Technical Peer Review – District Wide Regulation Model, Version 2 Southwest Florida Water Management District

Peer Review Panel

In the summer of 2008, the District initiated a voluntary peer review of DWRM2. The purpose of the peer review was to provide a critical, constructive, technical evaluation of DWRM2 and the FTMR procedure. The peer review was performed to determine the model's capacity to accurately simulate impacts to water resources of the District. Because DWRM2 was developed specifically for use in FTMR applications for water-use permit applications, the panel focused on the model's capacity to accurately simulate drawdown and changes in surface-water boundary condition flows at a combination of regional and FTMR scales instead of the model's capacity to simulate absolute water-level elevations. Specific peer review objectives stated in the scope of work (SWFWMD, 2008) for the peer review include determining whether DWRM2 is:

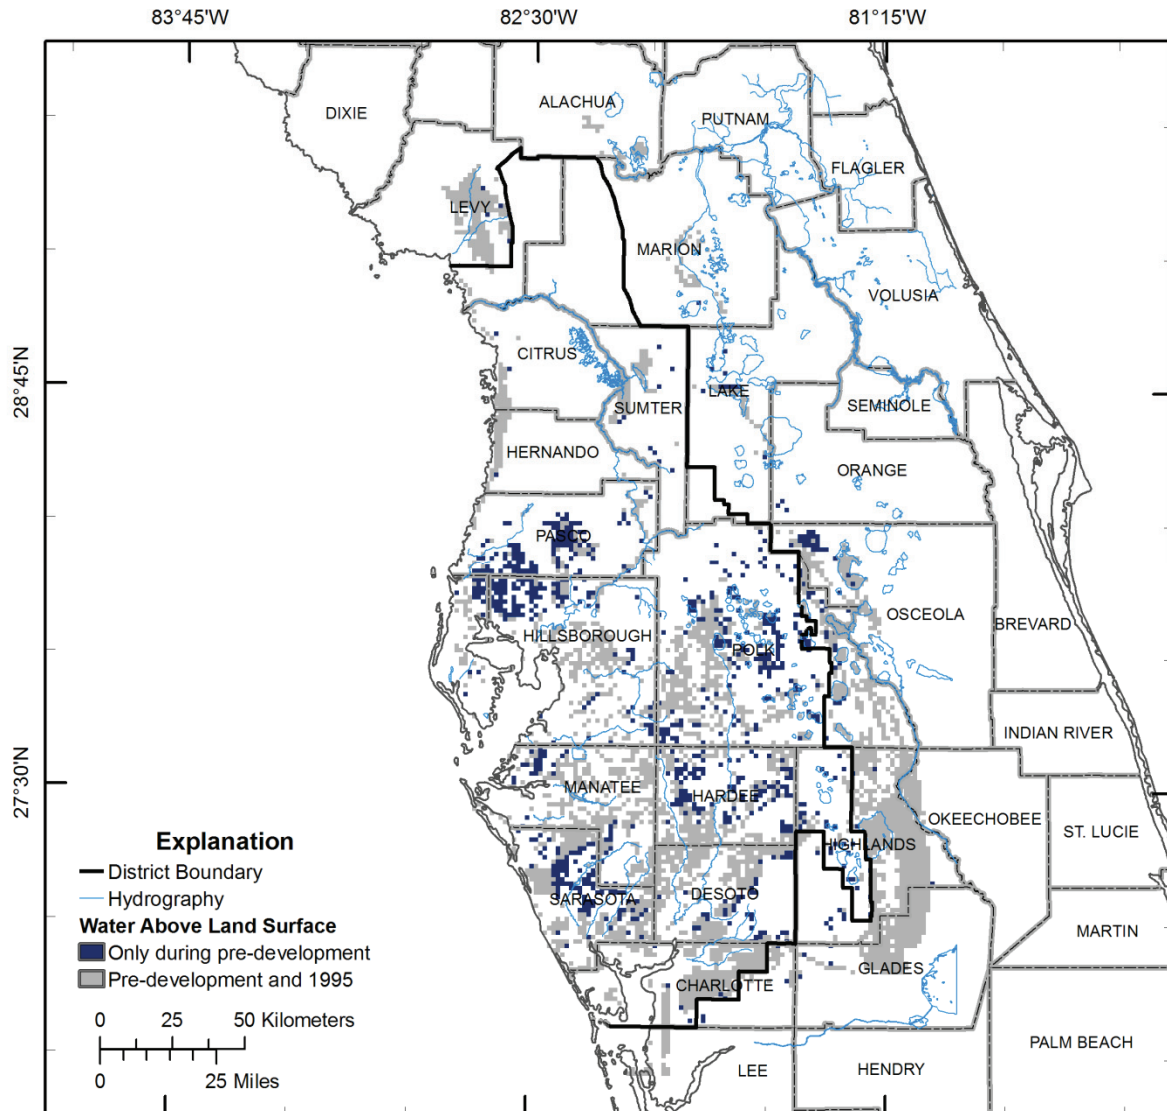
Areas where simulated SAS water levels are above land surface during predevelopment and 1995 conditions are shown in Figure 14. As expected, areas where SAS water levels are above land surface are less extensive in 1995, as a result of ground-water withdrawals, than during pre-development conditions. Extensive portions of the SWUCA have simulated SAS water levels above land surface. Areas where SAS water levels are above land surface are important for FTMR cumulative analysis. These results indicate excess recharge is being applied in these areas and decreases in water levels resulting from increased ground-water withdrawals would likely be under-predicted in FTMR cumulative analysis. It is recommended that DWRM2 be further evaluated to determine defensible approaches (for example, revision of net recharge data, refined river cell development, incorporation of additional calibration target data types, and others) to eliminate areas where water levels are not expected to be above land surface.

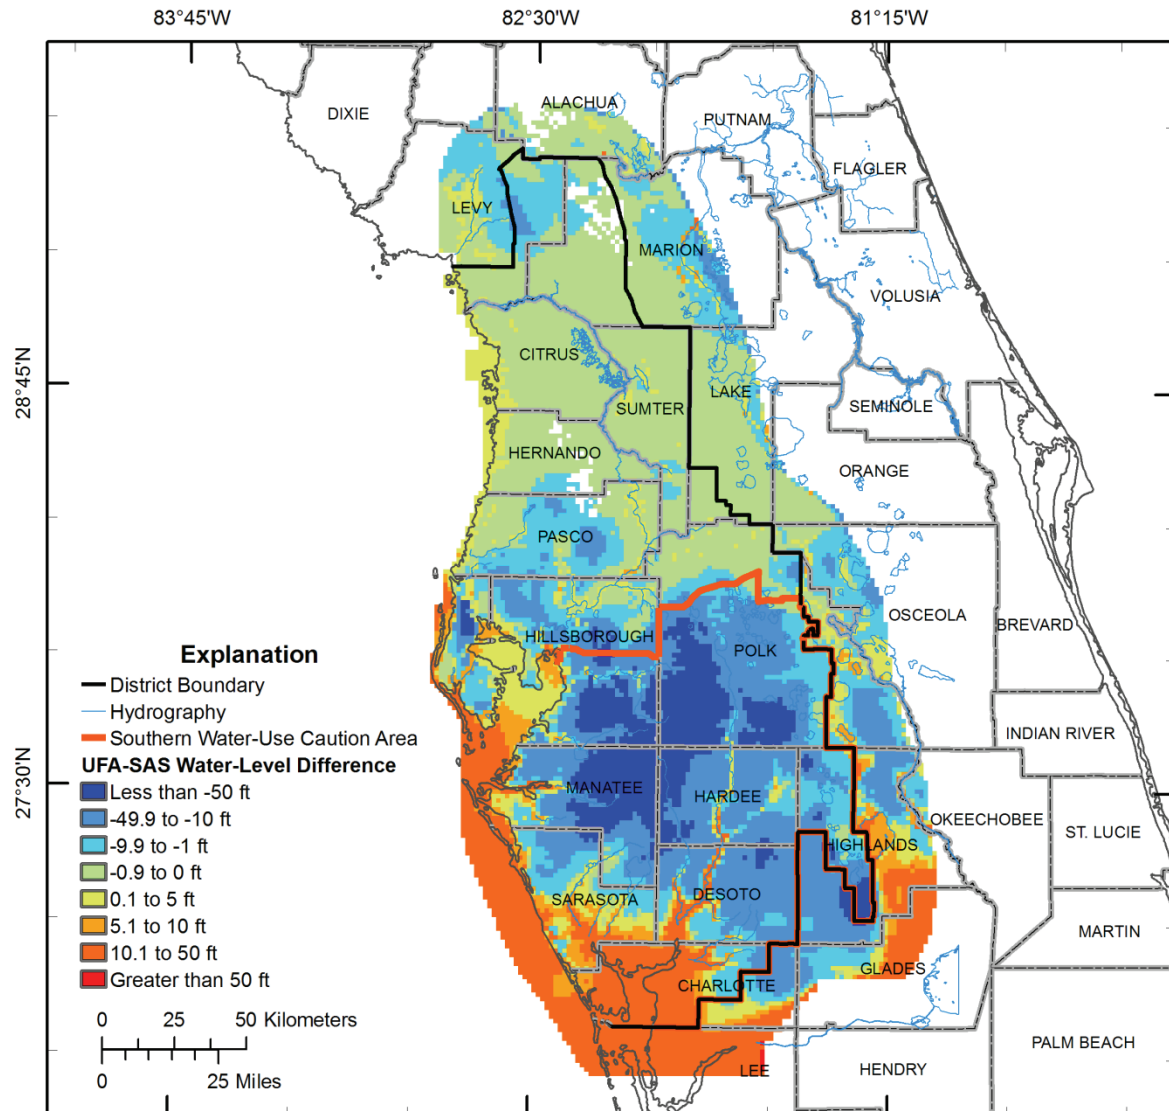
The simulated difference between UFA and SAS water levels during 1995 conditions is shown in Figure 15. There is little difference between water levels in the UFA and SAS in northern portions of the SWFWMD even though topography varies appreciably in this area and the UFA is partially confined in northeastern portions of the DWRM2 model domain. In the SWUCA, simulated differences between SAS and UFA water levels are more than 50 ft (SAS water levels are more than 50 ft above UFA water levels) in many cells. The SAS-UFA water-level difference residuals (124 paired wells) are approximately normally distributed as a result of calibration to water-level targets (see Figure 16), although the dependence of water levels on leakance parameters was not explicitly incorporated in the calibration process. Large positive water-level differences (in recharge areas; see Figure 5) are under-predicted and large negative water-level differences (discharge areas) are over-predicted (see Figure 17a). SAS-UFA water-level difference residuals (Figure 17b) are generally greater than 10% of observed SAS-UFA water-

Figure 17 a) Difference between observed and simulated SAS-UFA water levels and b) absolute value of the percentage of the SAS-UFA water-level difference residual to observed SAS-UFA water-level difference. Percent errors shown in b) are a measure of absolute SAS-UFA vertical flow errors in DWRM2.

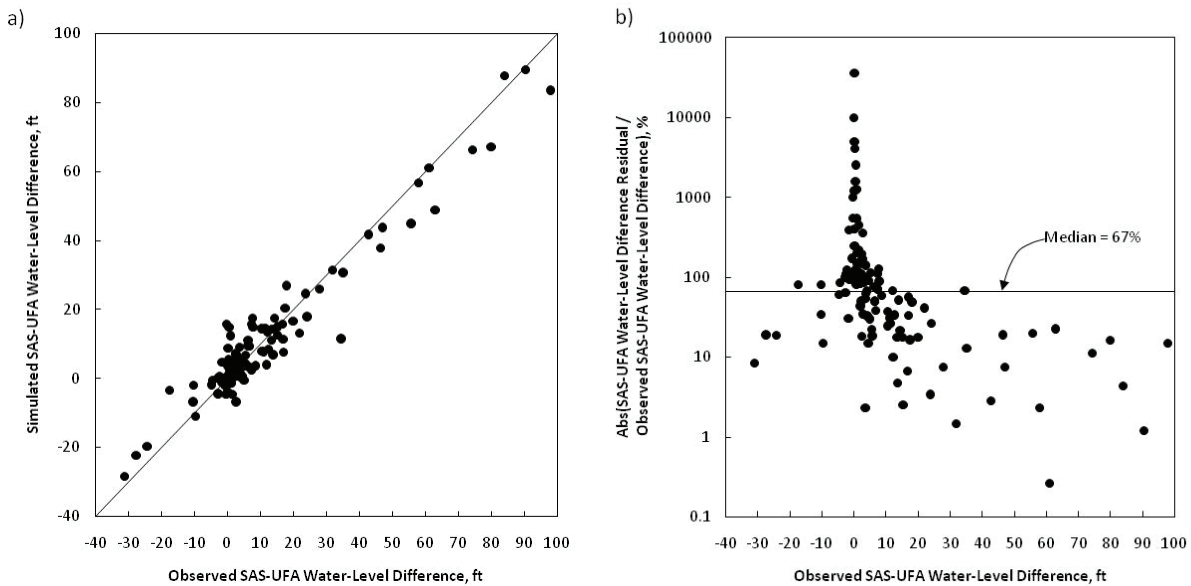
level differences (mean = 581%, median = 67%). For a defined leakance value, percent error shown in Figure 17b is a direct measure of absolute error in simulated vertical flow between the SAS and UFA. As a result, it appears there is significant bias in simulated SAS- UFA water-level differences and that calibrated leakance and/or specified recharge values may not be accurate.

DWRM2 is biased toward high values of simulated base flow, especially when simulated drain flow is also considered. DWRM2 is biased low for cumulative UFA spring flow. Simulated water levels do not appear to be biased, although there is a bias in simulated SAS-UFA water-level differences. Simulated SAS-UFA water-level differences are under-predicted at relatively high water-level differences corresponding to recharge conditions, and are over-predicted under discharge conditions (see Figure 17).

It is recommended that water-level differences be incorporated in the automatic calibration process to improve simulated SAS-UFA water-level differences. Furthermore, it is likely that use of SAS water-level elevation targets instead of DTW targets is introducing a positive bias into simulated SAS water levels. It is not uncommon for monitor wells to be located at relatively high elevations; therefore, in cases where water-level elevations measured in monitor wells are higher than the average water-level elevation assigned to a grid cell, water-level elevations higher than land surface will result with the use of the

Figure 18 Simulated steady-state aquifer-river exchange in DWRM2. Discharge represents flow from the aquifer to surface-water features (base flow) and recharge represents flow from surface-water features to the aquifer (river seepage). Aquifer-river exchange is zero in white areas.

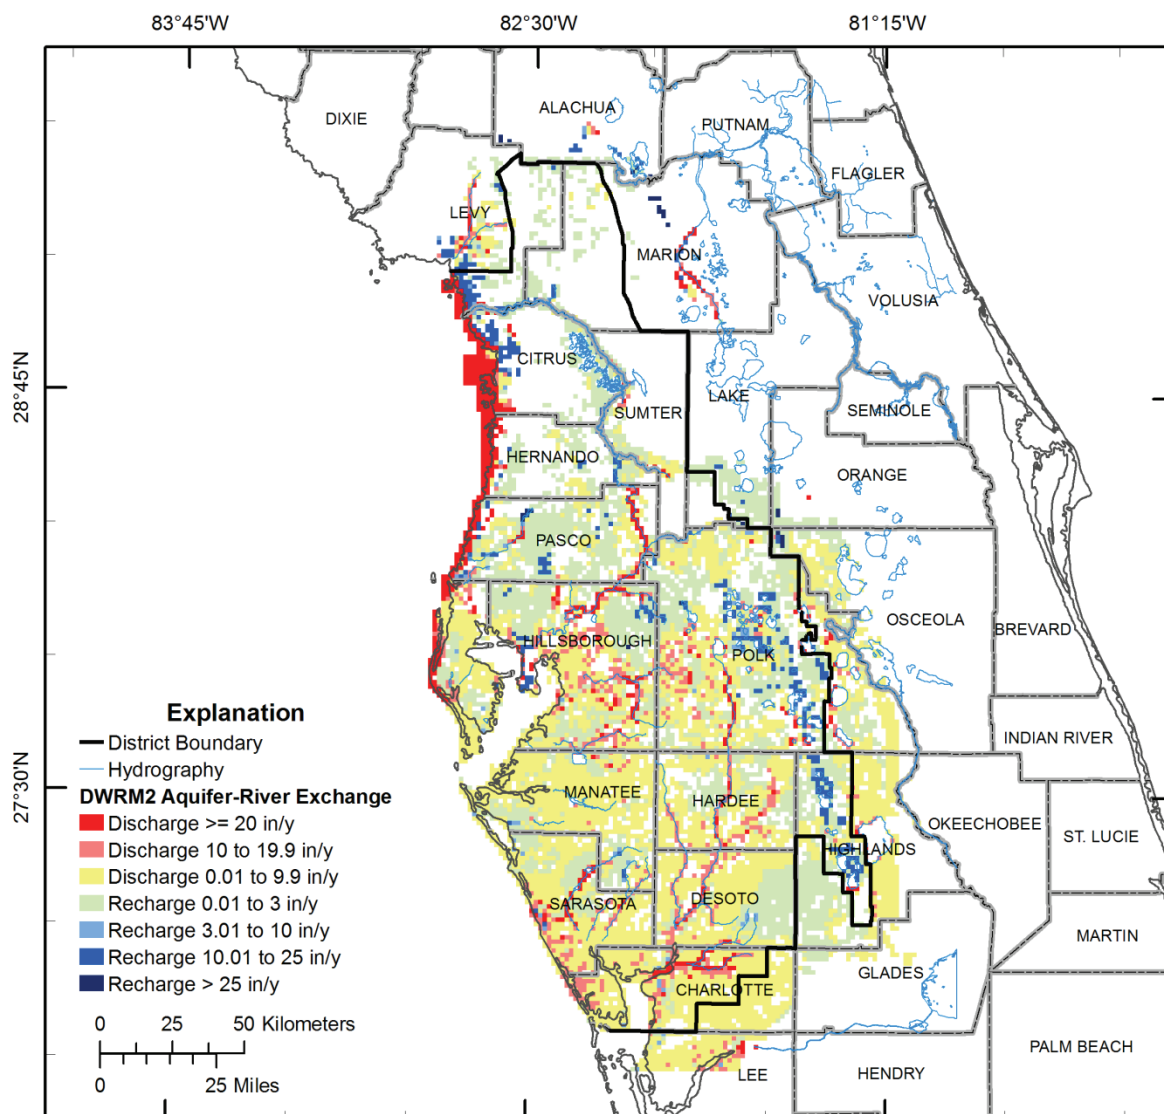
The spatial distribution of SAS river cell base flow is shown in Figure 18. The range of base flow is summarized in Table 1 and varies from -1,684 to 175 in/y in individual grid cells. Based on observed data, the magnitude of the upper and lower range of base flow greatly exceeds expected ranges. Estimated base flow in the Hillsborough, Alafia, Little Manatee, and Peace Rivers is summarized in Table 2 and averaged 1,022 ft³/s in 1995 (Geurink and others, 2000).

DWRM2 over-predicts base flow by 20% in 1995 and simulated base flow does not include drainage from wetland and drains used to limit water levels above land surface. Simulated SAS drainage flow should be combined with simulated SAS river flow to account for all base flow discharging to the surface-water system and lost from the system at the coast or as evapotranspiration. If this combination were done, simulated base flow would be over-predicted by more than 20% (see the **Aquifer-Drain Exchange** section). Furthermore, because base flow was not specifically incorporated in the automatic calibration process, there is significant uncertainty about how well the current distribution of model parameters and boundary conditions represents the ground-water system.

Figure 19 Daily streamflow in 1995 at Hillsborough River at Morris Bridge near Thonotosassa, Florida. Calculated base flow using a 60- and 120-day moving average of minimum streamflow for the same moving period is also shown.

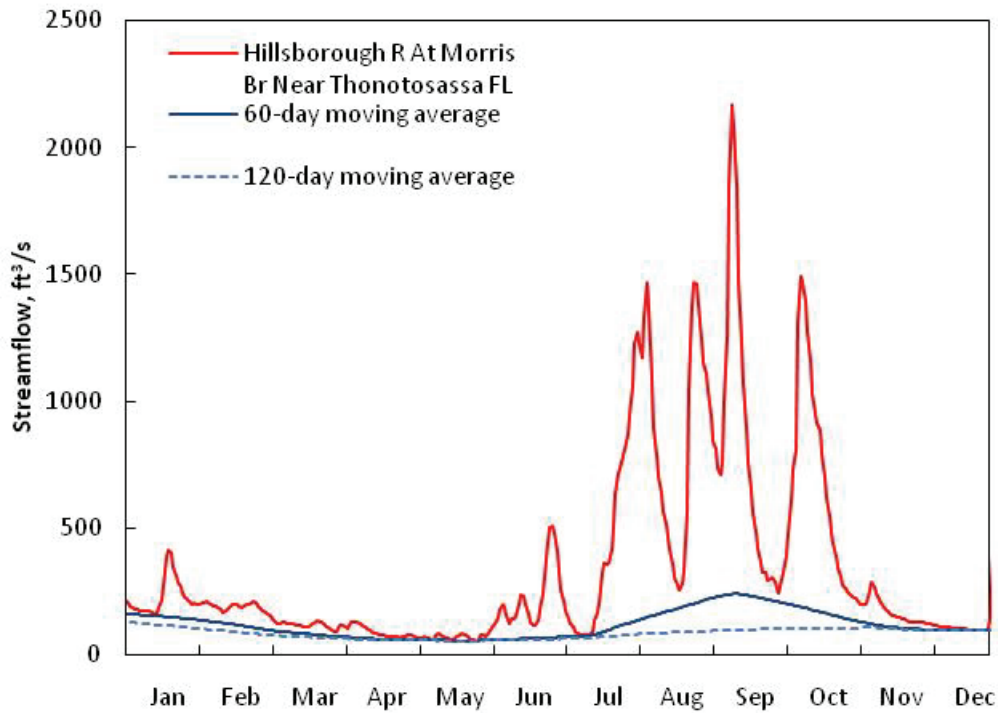
Daily measured streamflow for 1995 at the Hillsborough River at Morris Bridge near Thonotosassa, Florida station is shown in Figure 19 along with base-flow estimates using the algorithm of Weber and Perry (2006) and 60- and 120-day moving periods. This example was chosen because it represents the river segment with the largest percent error in DWRM2. Average streamflow and base flow calculated with a 60-day moving period for 1995 were 335 and 116 ft³/s, respectively, whereas simulated base flow for the Hillsborough River Basin was 197 ft³/s. Base flow calculated using a 60-day moving period represents 36% of the total flow measured at this location. Simulated base flow represents 59% of the total flow at this location and is approximately a factor of two (2) greater than computed values; the difference is even greater if the base flow calculated using a 120-day moving period (82 ft³/s) is used or SAS drainage flow were included in the simulated DWRM2 base flow .

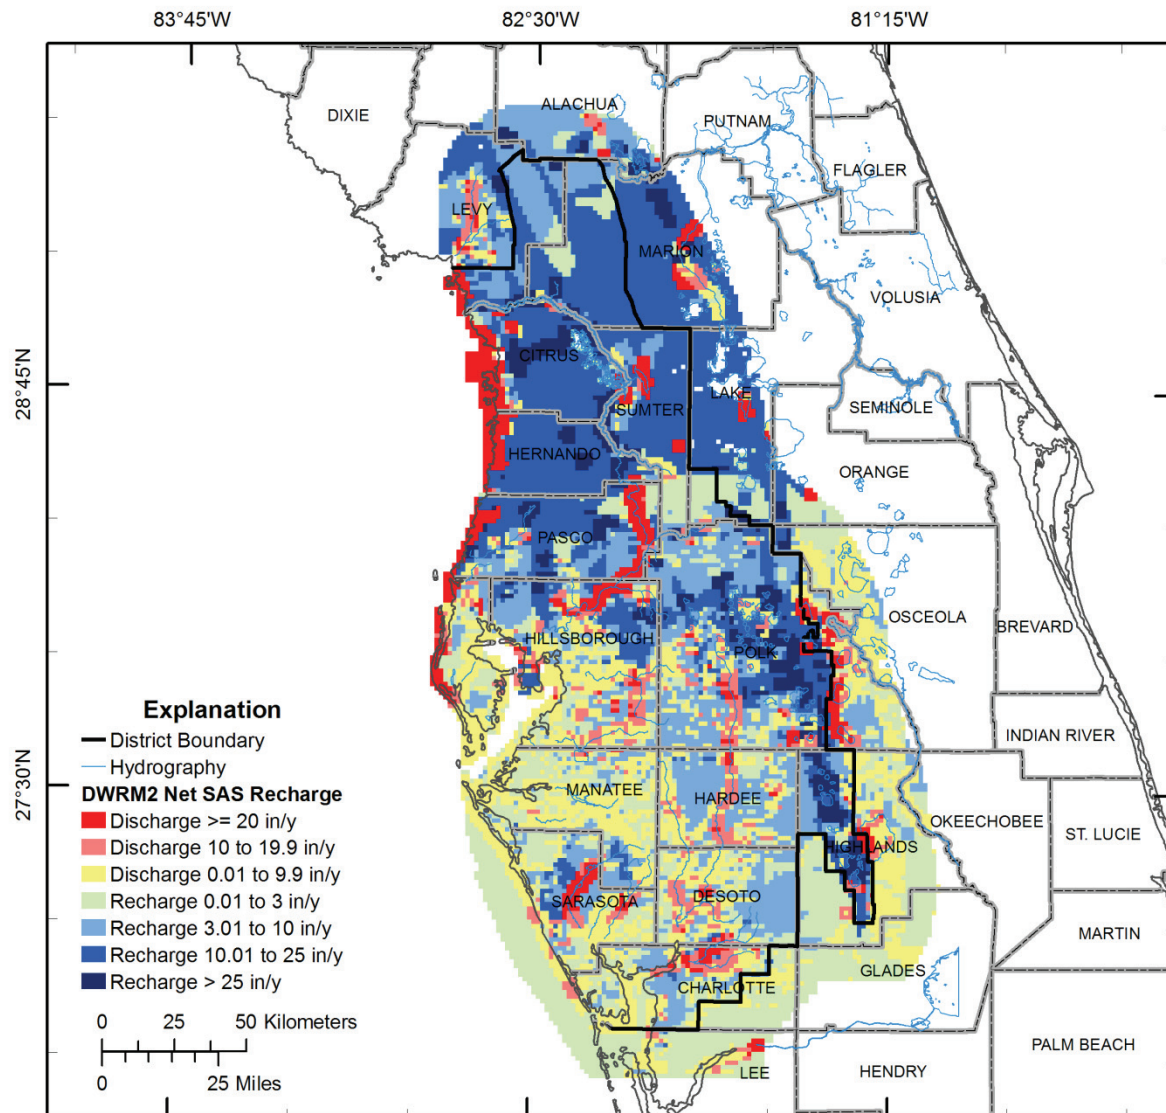
Net SAS recharge is shown in Figure 21 and, in general, appears to be reasonable over the model domain. The range of net SAS recharge is summarized in Table 1 and varies from -1,684 to 108 in/y in individual grid cells and averages 1.02 in/y in grid cells receiving recharge. Discharge is observed in the vicinity of most major rivers and along the coast. Areas where simulated net ground-water recharge or discharge exceeds expected ranges include Desoto, Highlands, southern Hillsborough, Manatee, Osceola, and eastern Sarasota Counties within the SWUCA. As simulated, these areas receive no net recharge and are discharge areas; discharge conditions are expected in coastal areas and in the vicinity of rivers, but are not expected throughout upland areas of the SWUCA.

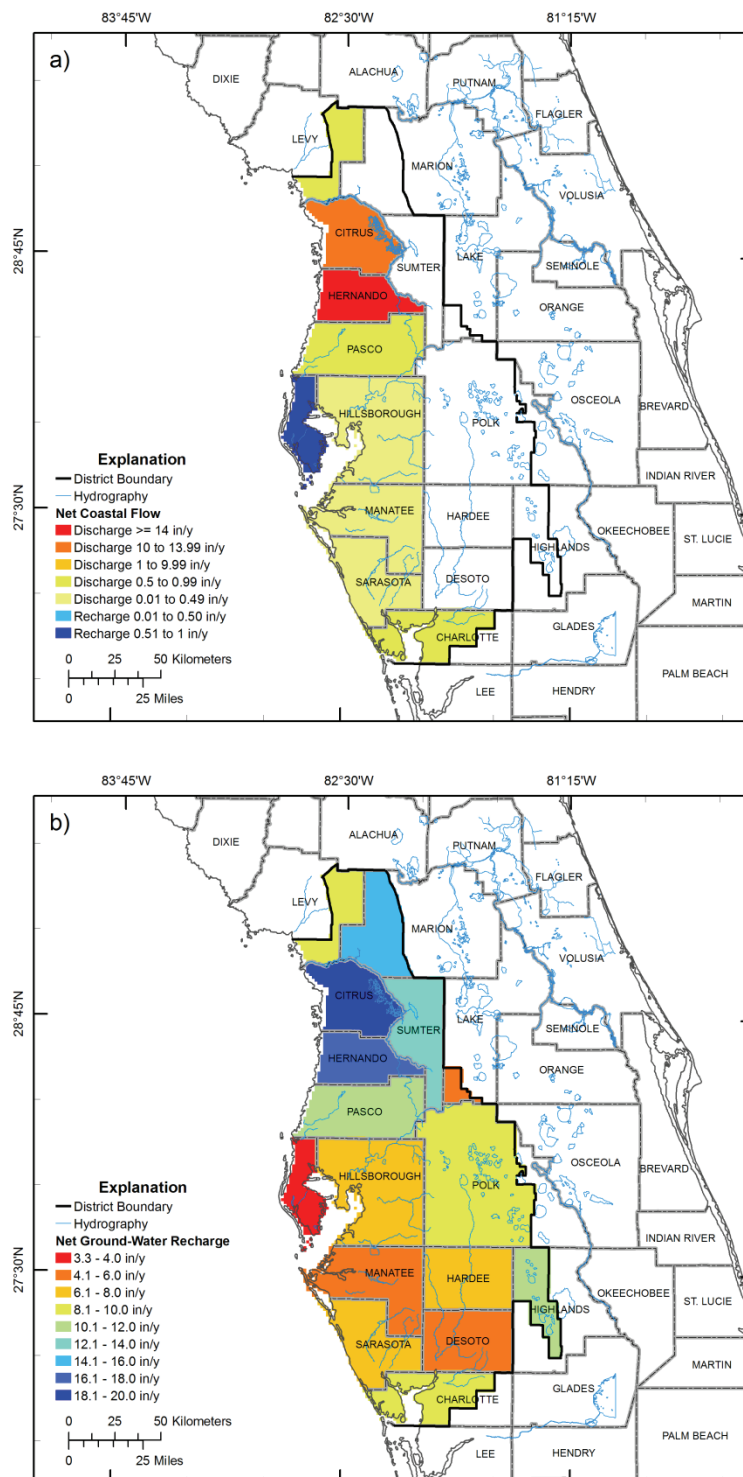
Net coastal flow in counties adjacent to the coast is shown in Figure 23a. Except for Pinellas County, net ground-water flow was to the coast. However, inflows from coastal boundaries were simulated in Charlotte, Citrus, Hillsborough, Manatee, Pasco, Pinellas, and Sarasota Counties. Except for Hillsborough and Pinellas Counties, coastal inflows were significantly less than coastal outflows. Coastal inflows are need to be carefully considered because it is expected that general ground-water flow direction in the ground-water system is towards the coast. Coastal inflows would appreciably affect the simulation of ground-water withdrawal impacts (specifically in FTMR model applications) near the coast.

Net recharge rates for counties within the District are shown in Figure 23b. Net recharge rates in Lake County are significantly less than rates for adjacent Sumter and Marion Counties. Net recharge rates in Highlands County are significantly higher than adjacent Desoto and Hardee Counties. Because of similarities in topography, soils, and confinement of the UFA, it is expected that net recharge in these adjacent counties would be similar. Net recharge in Pinellas County is significantly less than adjacent Hillsborough and Pasco Counties, but this difference is consistent with a higher degree of confinement in Pinellas County relative to Hillsborough and Pasco Counties.
